# COUNCIL ASSESSMENT REPORT

<b>Panel Reference</b>	PPSSWC-396
<b>DA Number</b>	1/2024/DA-I
<b>LGA</b>	Campbelltown
<b>Proposed Development</b>	Demolition of existing structures, construction of a warehouse and distribution facility comprising two separate buildings, each containing two warehouses (with each warehouse containing a mezzanine office level), two undercroft car parking areas, tree removal, civil works and landscaping
<b>Street Address</b>	50 Airds Road, Minto (Lot 5022 DP 1012382)
<b>Applicant/Owner</b>	ESR Investment Nominees 3 (Australia) Pty Ltd
<b>Date of DA lodgement</b>	6 February 2024
<b>Total number of Submissions</b>	0
<b>Recommendation</b>	Approval
<b>Regional Development Criteria (Schedule 6 of the Planning Systems SEPP)</b>	Development with a Capital Investment Value (CIV) of over \$30 million
<b>List of all relevant s4.15(1)(a) matters</b>	<ul style="list-style-type: none"> <li>• State Environmental Planning Policy (Planning Systems) 2021</li> <li>• State Environmental Planning Policy (Industry and Employment) 2021</li> <li>• State Environmental Planning Policy (Transport and Infrastructure) 2021</li> <li>• State Environmental Planning Policy (Resilience a

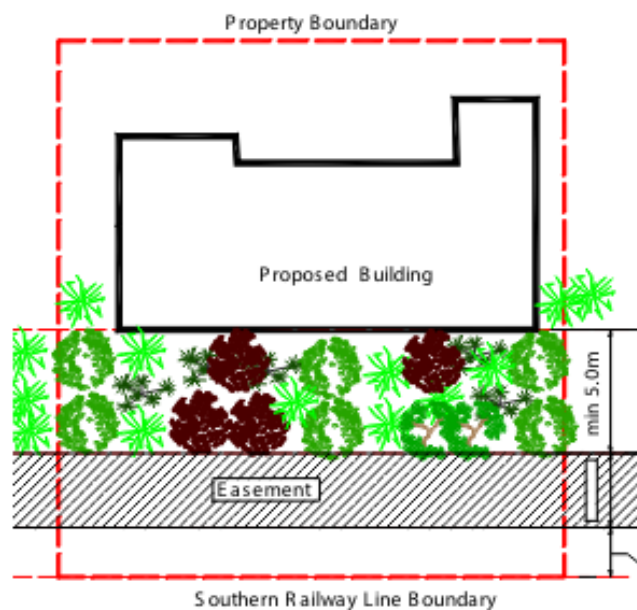
The proposed development fails to comply with subclause (ii) above as the required 5 metre wide vegetated area is proposed to be entirely within a 22.5m wide easement stormwater drainage and electricity transmission easement that traverses the eastern portion of the site.

However, despite the proposed non-compliance with the development standard in question, the proposed configuration of the development is considered to be satisfactory because concurrence has been received from Endeavour Energy in relation to the proposed development, and the proposed landscaping would not interfere with the flow of stormwater through the stormwater easement.
